Office of Environment & Heritage

Your reference: MP07_0118 MOD 1
Our reference: DOC 14/44274
Contact: Virginia Thomas 6229 7105

RE: Gullen Range Wind Farm – MOD 1.

Thank you for your letter, received by email on 3 April 2014, requesting a submission from the Office of Environment and Heritage (OEH) on Modification 1 to the Gullen Range Wind Farm. OEH provides the following comments on the Modification report (MOD 1), in relation to biodiversity and Aboriginal heritage.

FIGURE 1

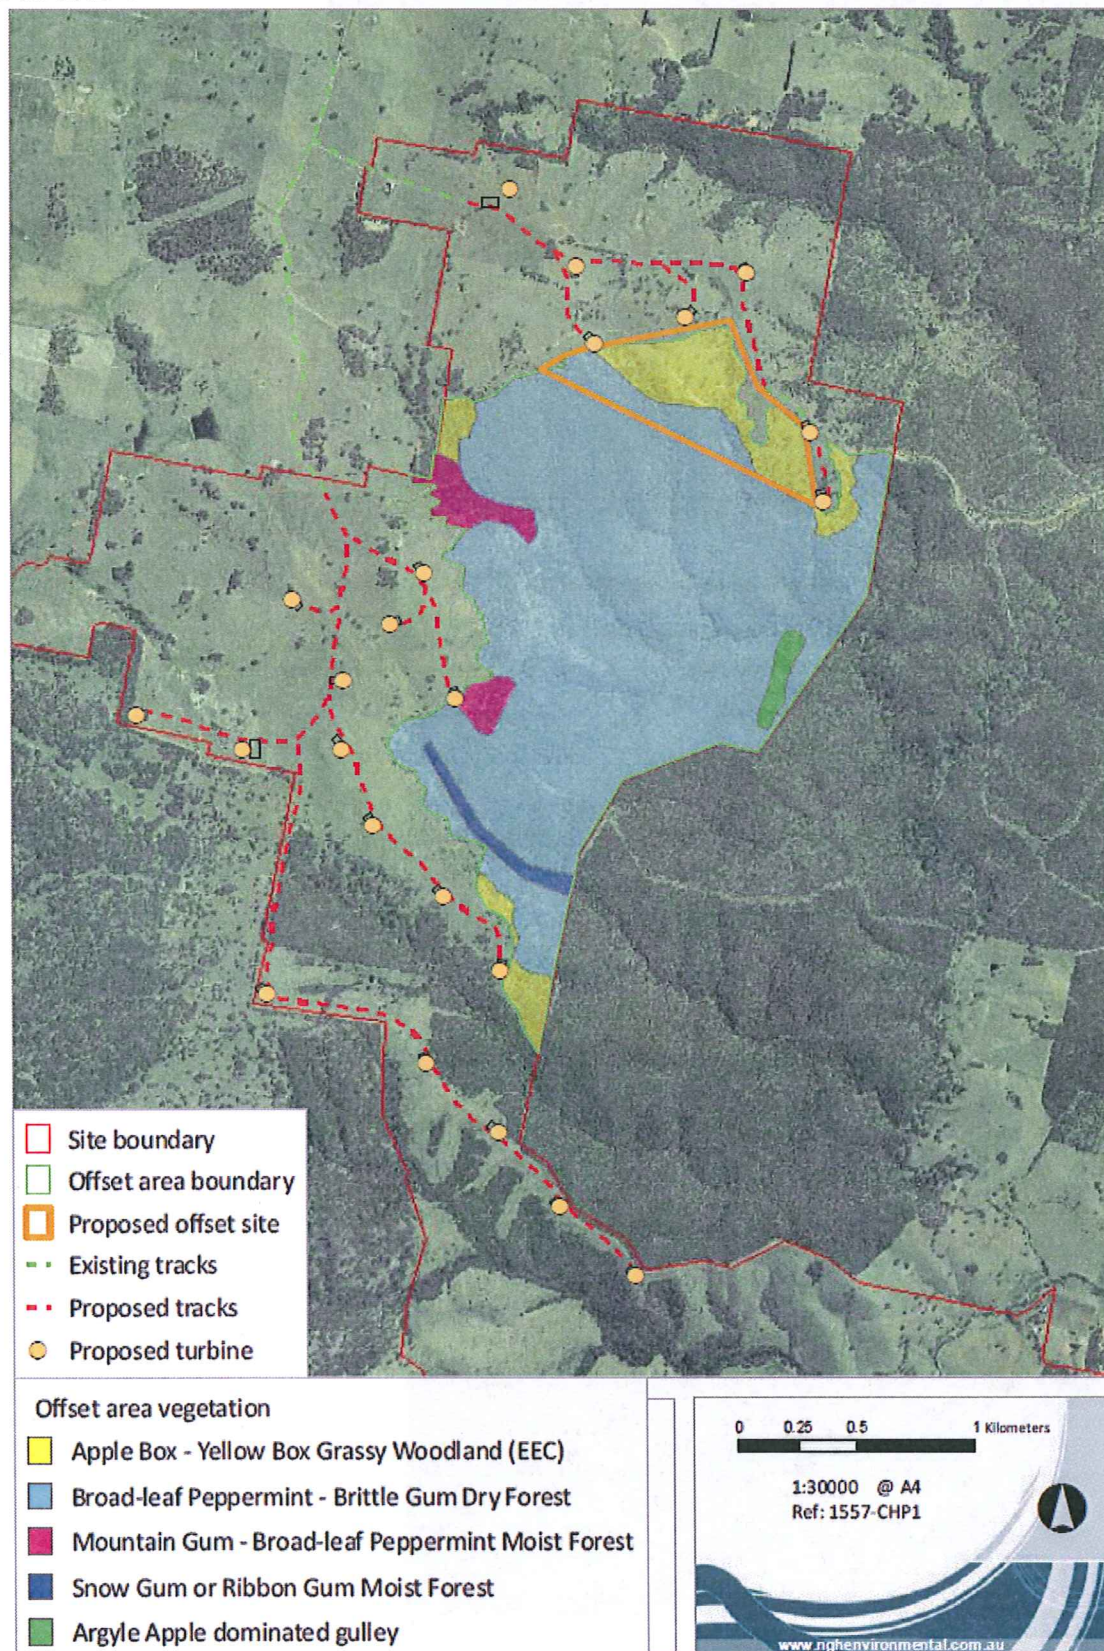
OEH seeks clarification as to why the vegetation mapping in the Compensatory Habitat Package (CHP) report (see **FIGURE 1**) shows considerably more Box Gum Woodland EEC within the proposed offset than the maps in the MOD 1 report (**FIGURE 2** and **FIGURE 3**). OEH requests that the proponent provide further information and clarification of the vegetation in the offset area. The CHP report states that the offset site comprises approximately 39.28 ha of “*mostly densely forested vegetation*” (p. 16) including 26.73 ha of Apple Box – Yellow Box Woodland and derived grassland EEC and 12.55 ha of Broad-leaf Peppermint – Brittle Gum Forest. These figures indicate that nearly 70% of the offset area is EEC.

There is no mention in the CHP report of turbines or infrastructure being constructed within the offset area. The Map included in the CHP indicates the turbines are right on the edge of the compensatory habitat area, however no roads or other infrastructure are shown within the area. The MOD 1 report indicates that two turbines (POM_06 and POM_07) and associated infrastructure have been constructed within the offset area. POM_06 has been moved into a patch of “degraded Box Gum Woodland EEC”. The MOD 1 report states: “*the constraints mapping is designed to protect the viability of the overstorey vegetation which in this location is sparse*”, and yet a tree was removed in this area of EEC to reposition the turbine 57m from the approved location. The report also states “*due to an error in GIS mapping, the location of POM_06 was not identified by the Principal Contractor, as being within an area of EEC. At the time of construction the ecologist did not identify the area as an EEC due to the extent of the degradation by infestation with Serrated Tussock.*” OEH seeks clarification of how this happened within the offset area, given the offset had been mapped as 70% EEC. OEH has identified that

the offset area indicated in the CHP appears to have a significantly different boundary than the area indicated in the MOD 1 as the offset area. OEH therefore requests clarification why the boundaries were altered and turbines placed in the Offset area.
